**RECONSTRUCTION
OF US-68 / KY-80
BETWEEN AURORA & CADIZ, KY
IN TRIGG AND MASHALL COUNTIES**
Item NO. 1-180.00

**VALUE ENGINEERING STUDY
for
Kentucky Transportation Cabinet**

Final Report

April 9, 1997

TYPICAL SKETCHES FOR MAIN SPAN ALTERNATES

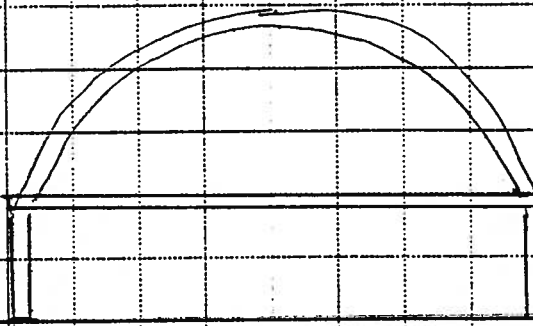
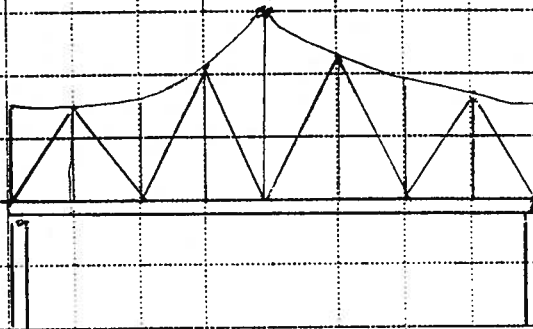
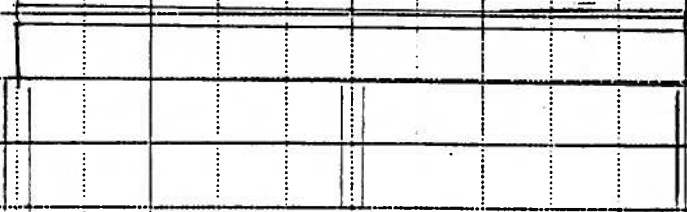
DESCRIPTIVE TITLE OF RECOMMENDATION: Consideration of alternate designs (tied arch, through steel truss, and steel box girder) as compared to the proposed design (steel girder).

ORIGINAL DESIGN:

Steel girder bridge structure

RECOMMENDED CHANGE:

Steel tied arch, through steel truss, or steel box girder.

- Required Coast Guard horizontal clearance of 500' will most likely exceed allowable span length of the steel girder design, rendering it unacceptable.
- The main spans proposed cost of \$115/sf appears too low. We believe it to be closer to \$175/sf.
- The approach spans proposed cost of \$80/sf appears too low. We believe it to be closer to \$100/sf.
- If further study indicates that the steel girder design is acceptable the revised above estimates are valid.

IDENTIFICATION NUMBER: C4a

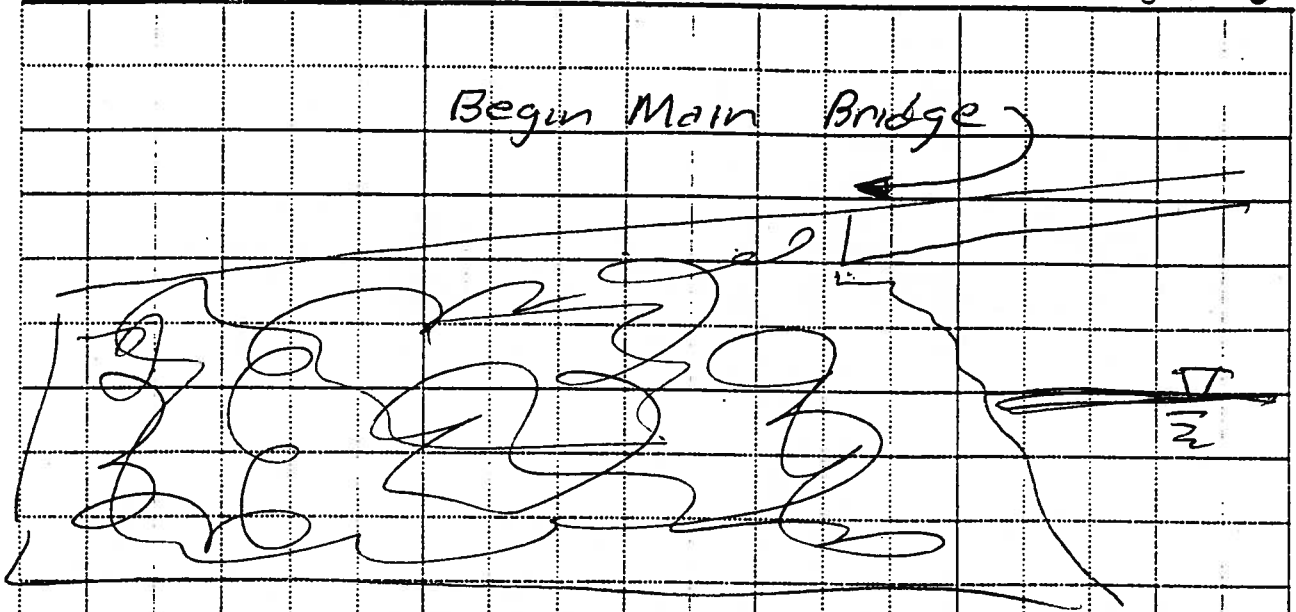
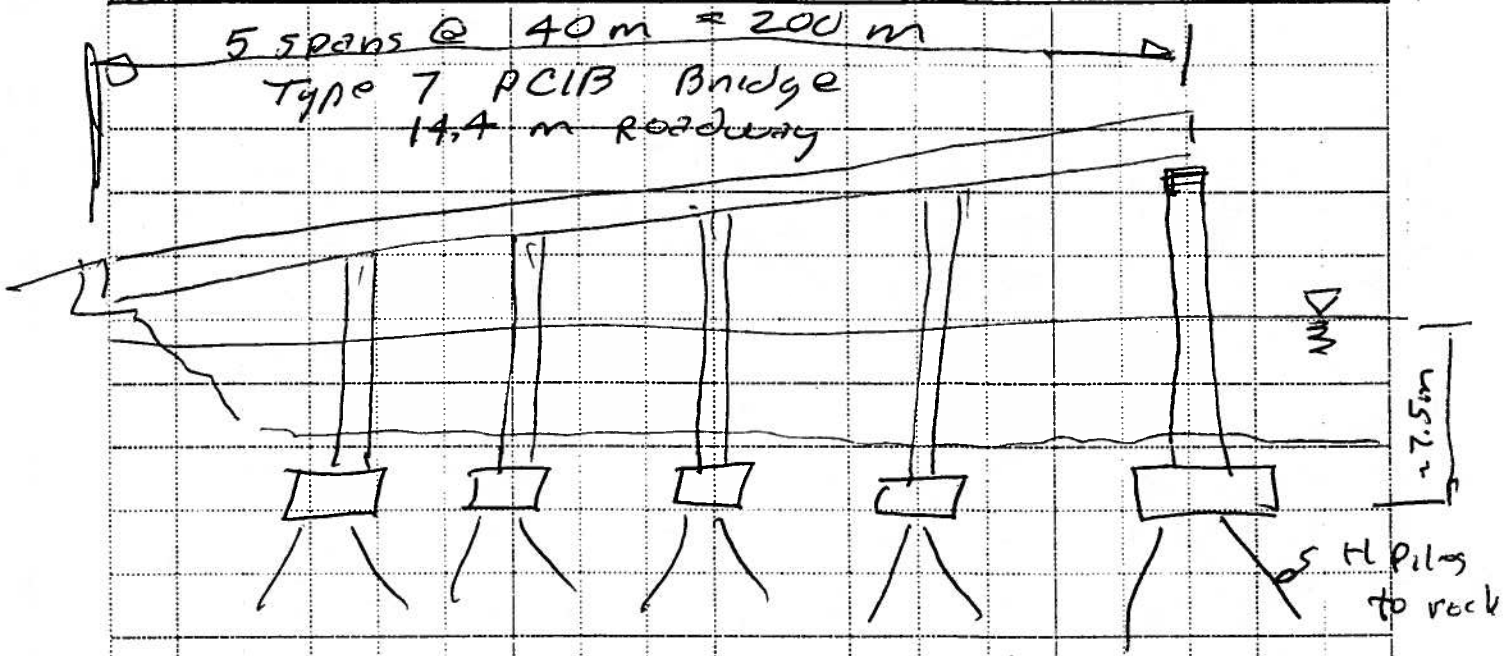
DESCRIPTIVE TITLE OF RECOMMENDATION: Lengthen bridge in lieu of widening causeway.

ORIGINAL DESIGN:

Widen existing causeway to reduce bridge length.

RECOMMENDED CHANGE:

Lengthen bridge and do not widen causeway. Causeway would still be used for future E.B. of four lane crossing.

The environmental factors alone would dictate not adding to the causeways. The fact that it would cost less and would not adversely effect lake volume are added benefits. The added maintenance cost of the approach spans over the causeway is insignificant over the 20 year life considered in this study.

IDENTIFICATION NUMBER: C4B

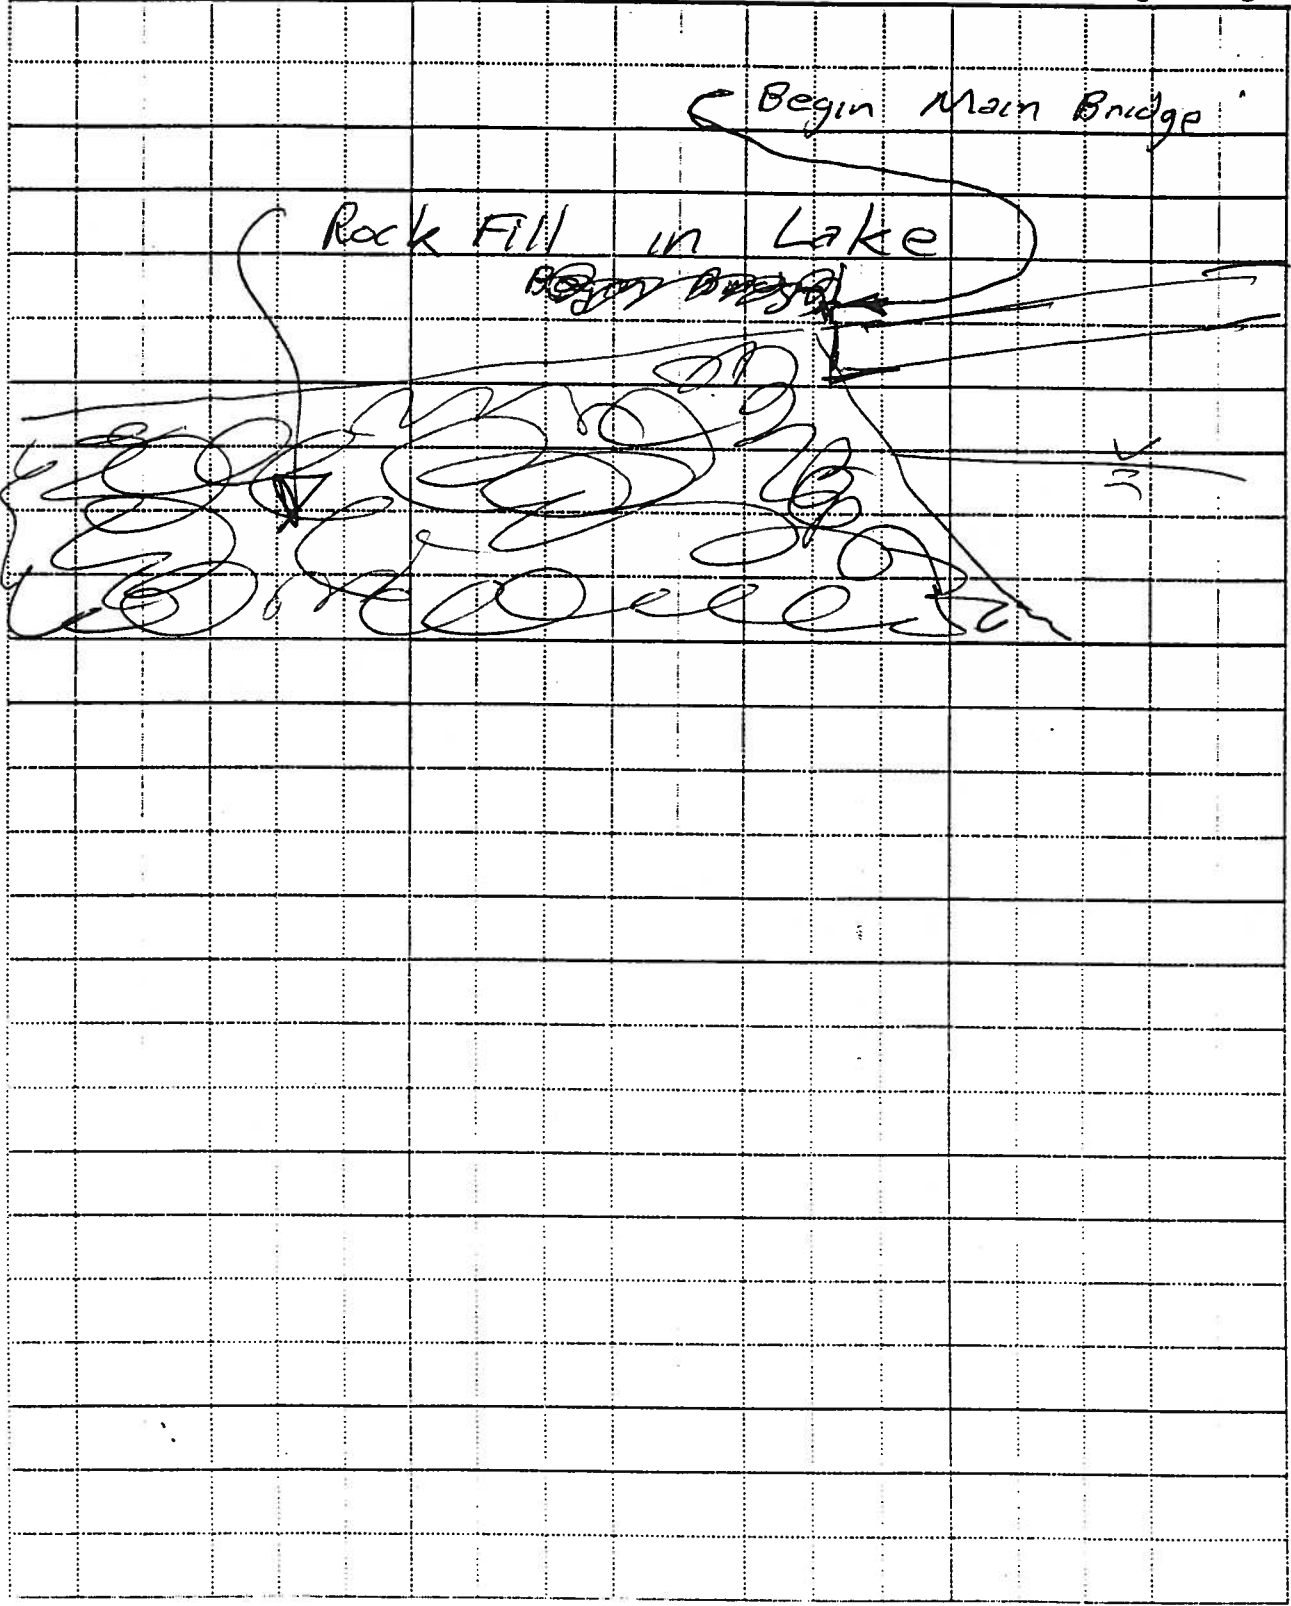
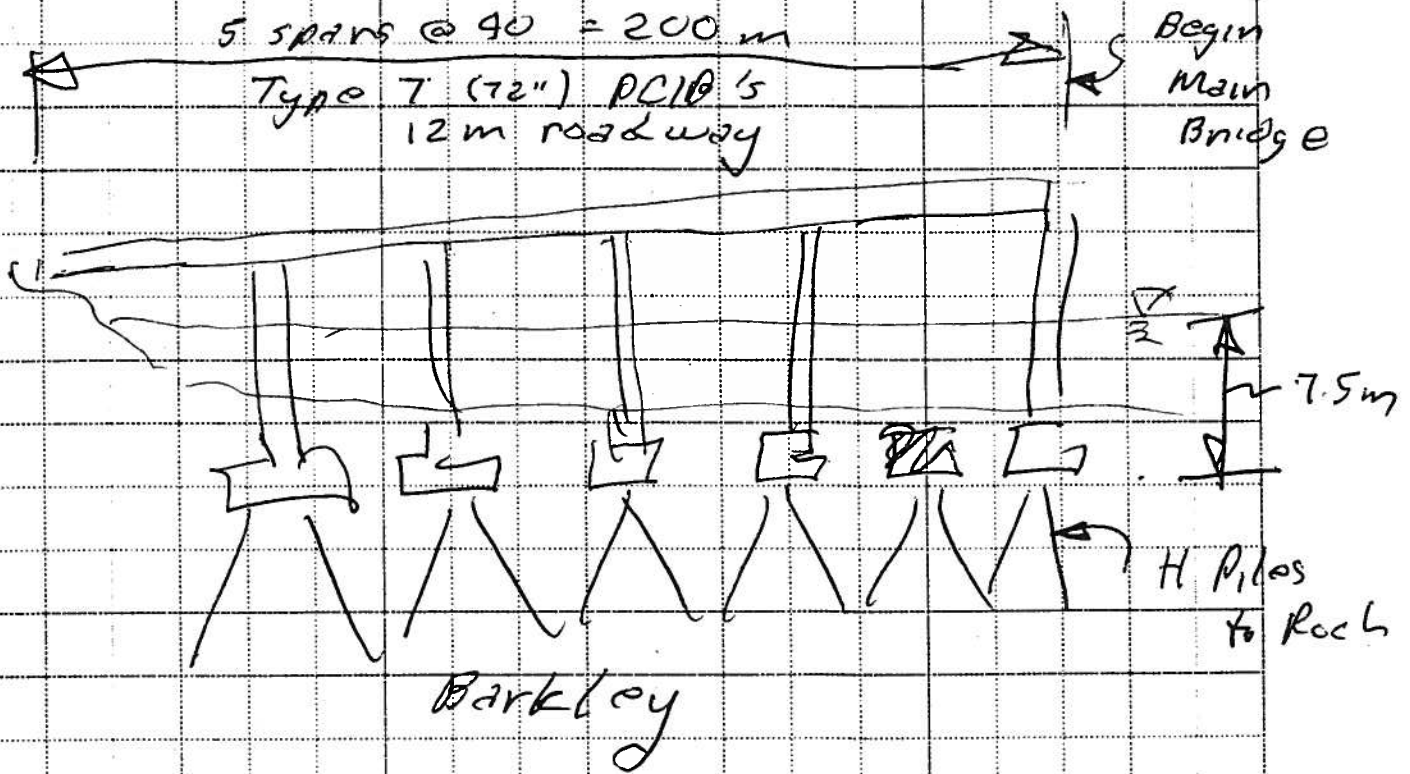
DESCRIPTIVE TITLE OF RECOMMENDATION: Use bridge instead of widening causeway
(for 4 lane crossing).

ORIGINAL DESIGN:

Widen existing causeway to reduce bridge length.

RECOMMENDED CHANGE:

Lengthen bridge and do not widen causeway. Use causeway for E.B. traffic.

The environmental factors alone would dictate not adding to the causeways. The fact that it would cost less and would not adversely effect lake volume is an added benefit.

IDENTIFICATION NUMBER: P-1

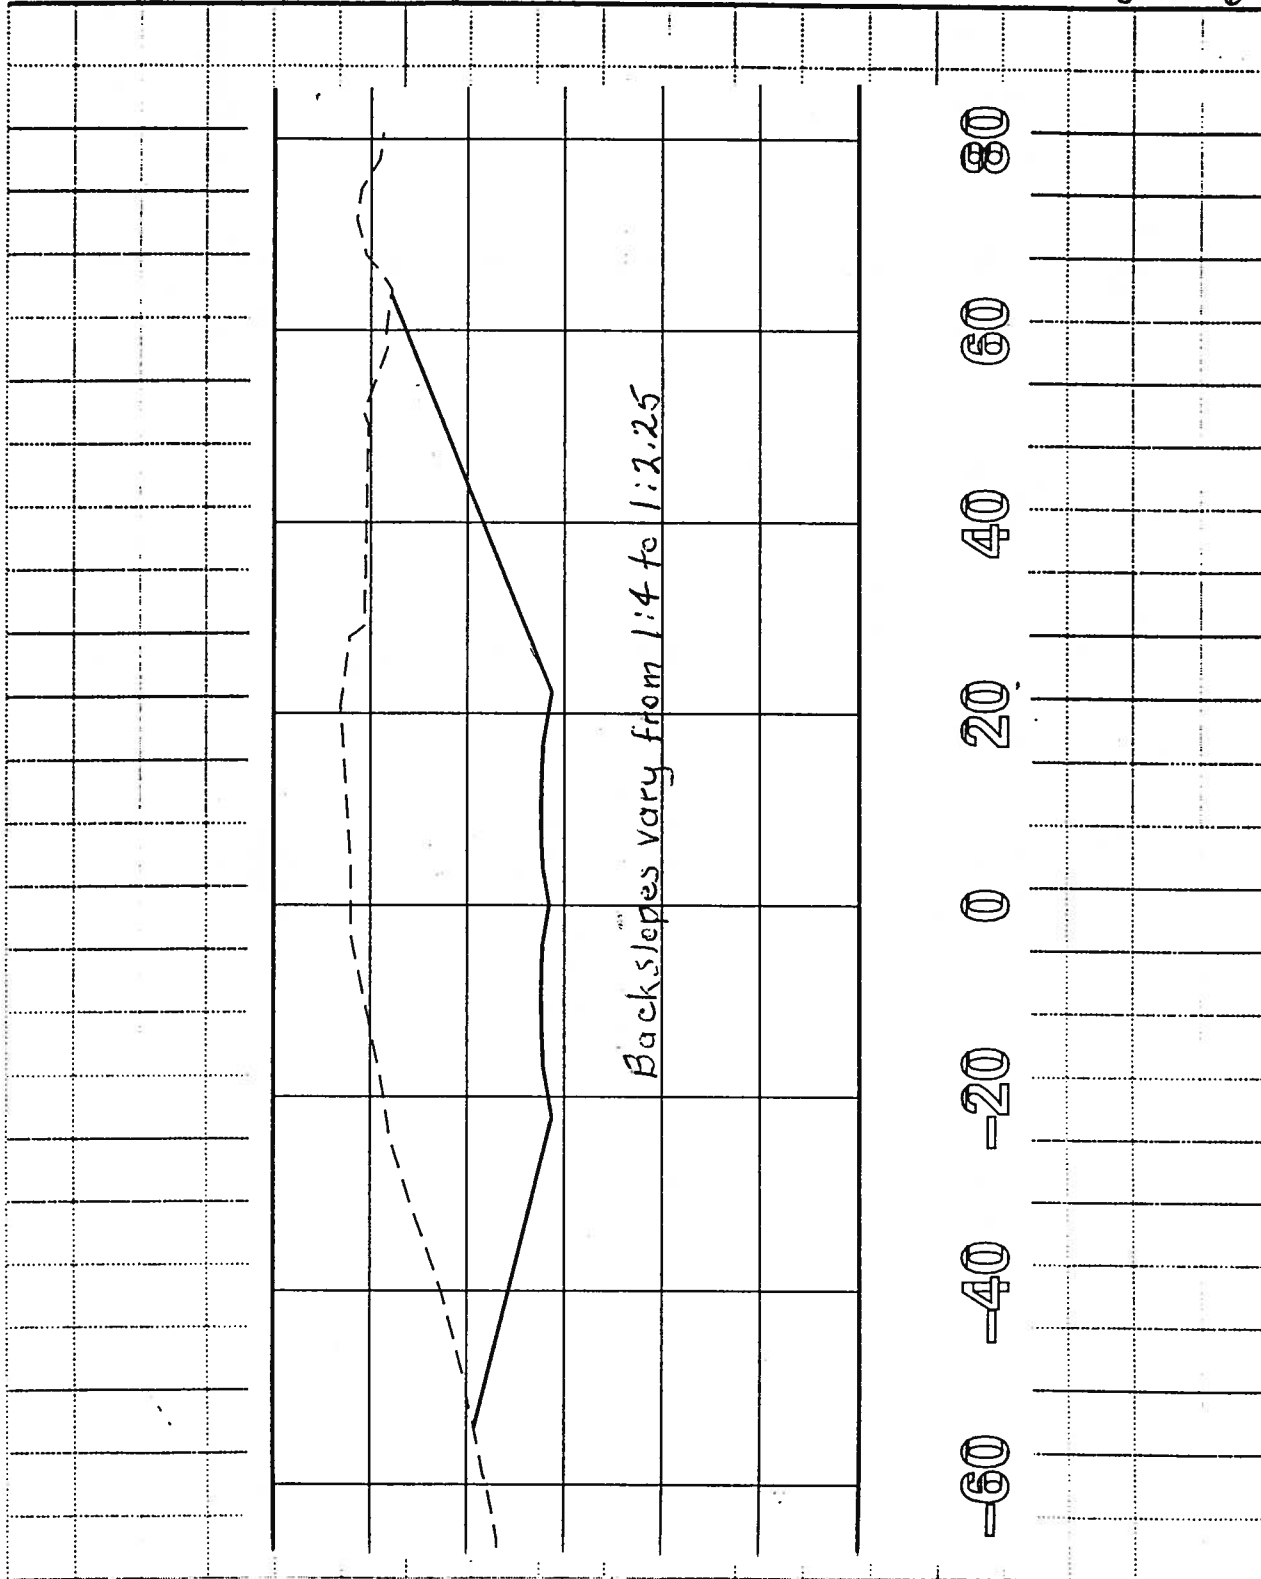
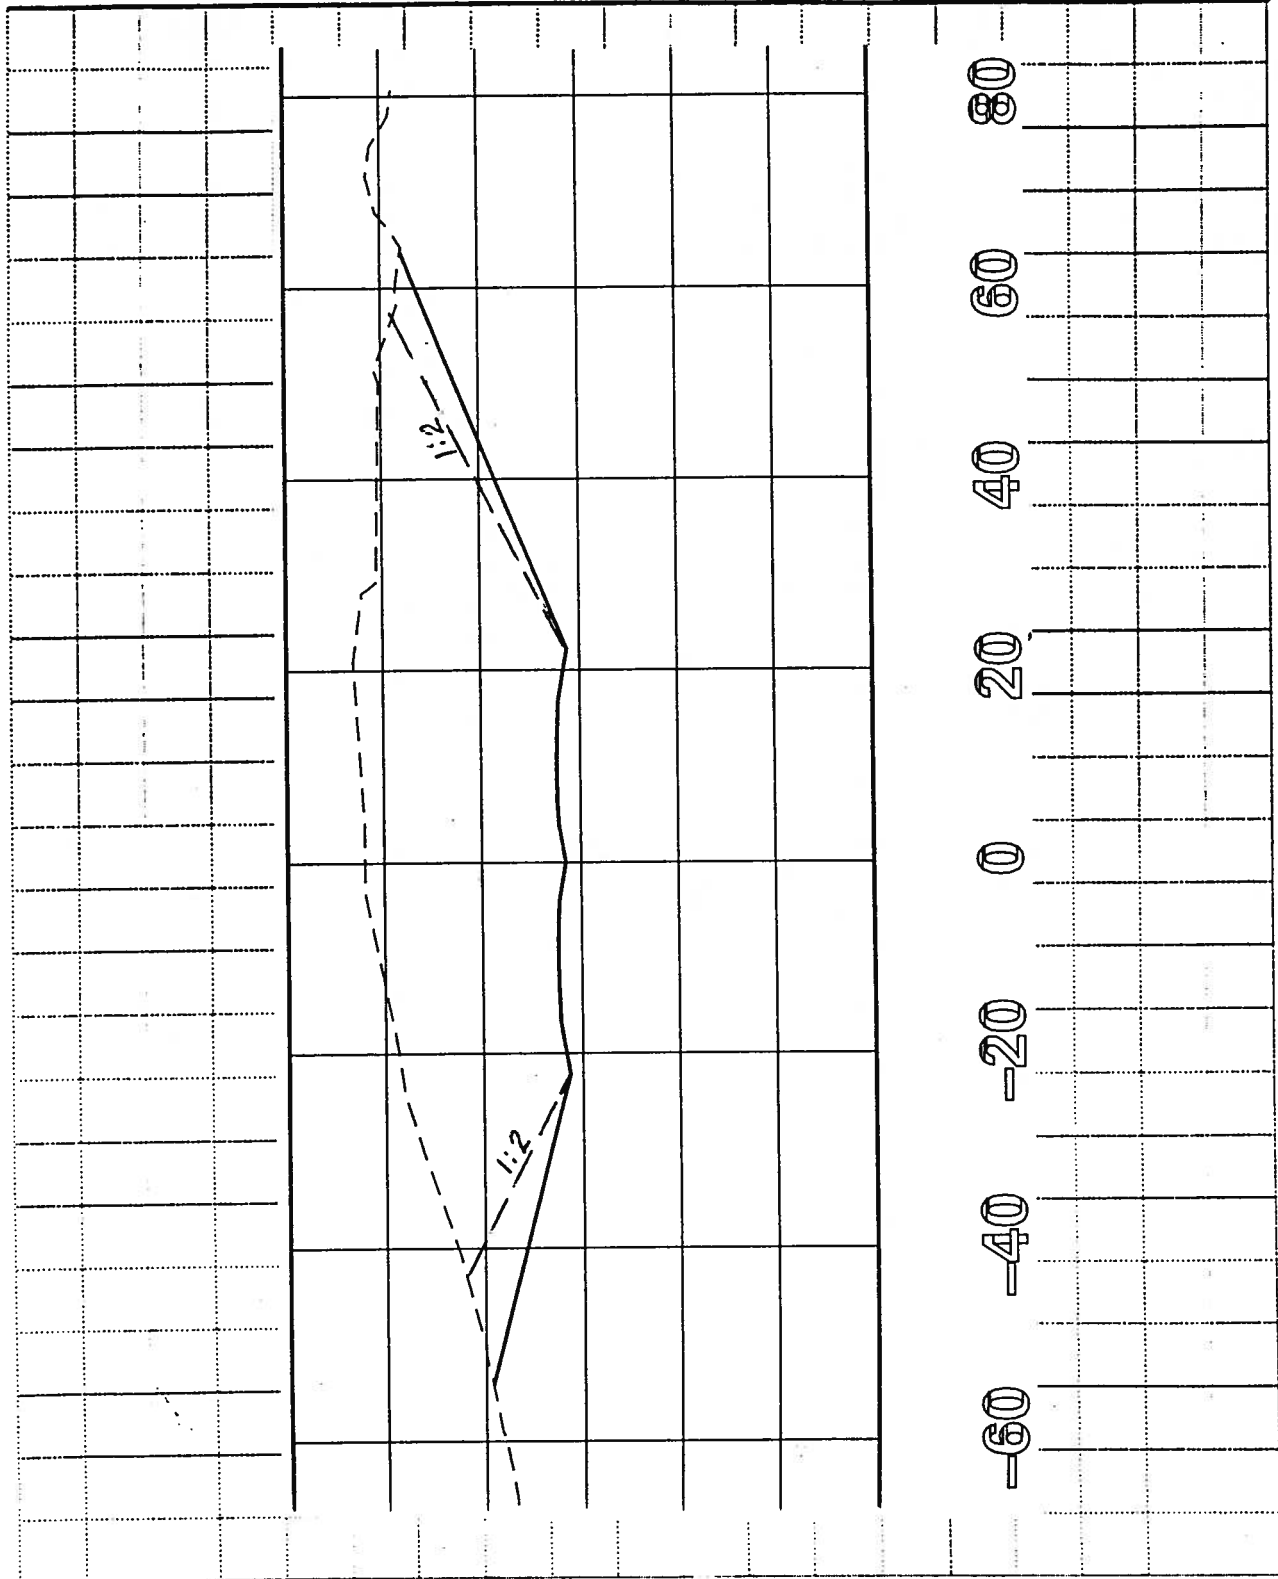
Section F - 180.52 - Revise grade from -3.588% to -4.00% from 11+740 back to 10+800.

1:2 backslopes over 3 meters are in concurrence with the proposed typical section. Reduces permanent easement required in land between the lakes area.

Section D - 180.53				
Roadway Excavation-				
Original Design -	543,442	Cu. Meter		
* Revised Design -	447,800			
	<u>95,642</u>			
* Backslopes revised to 1:2, Revision brought section into balance.				
Section F - 180.52				
Roadway Excavation -				
** Original Design -	816,000	Cu. Meter		
Revised Design -	591,500			
	<u>224,500</u>			
** Cross Sections indicated a greater amount of excavation than shown on original estimate.
